14 CFR Part 39

[Docket No. 83-ANE-14-AD]

Airworthiness Directives; Hartzell Propeller Inc. (formerly TRW Hartzell Propeller) Model HC-B3TN-2, HC-B3TN-3, HC-B3TN-5, HC-B4TN-3, HC-B4TN-5, HC-B4MN-5, and HC-B5MP-3 Turbopropellers

ACTION: Notice of proposed rulemaking (NPRM).

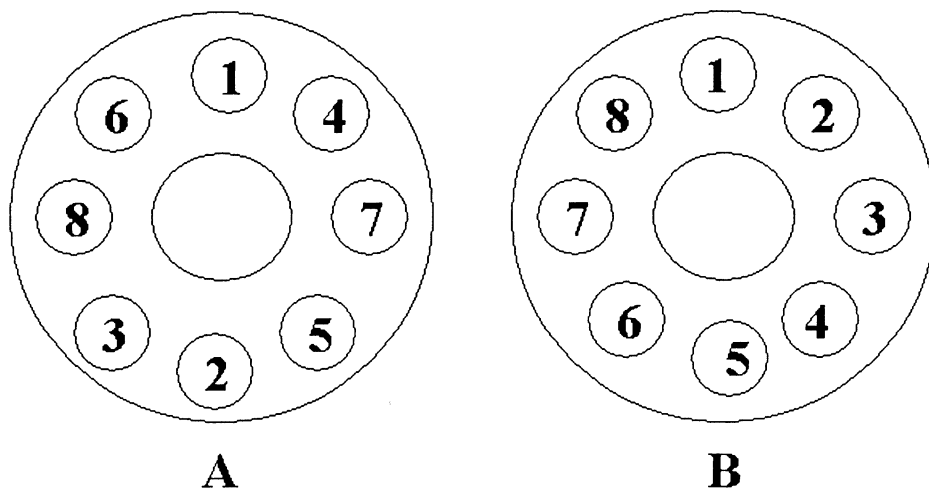
- (5) Torque all attaching bolts with a torque wrench and an appropriate adapter, to 40 ft.-lbs., and then to 80 ft.-lbs. Following sequence "A" (shown below). Final torque all attaching bolts using sequence "B" (shown below) to 100 to 105 ft.-lbs. Safety wire all attaching bolts in an FAA-approved manner.
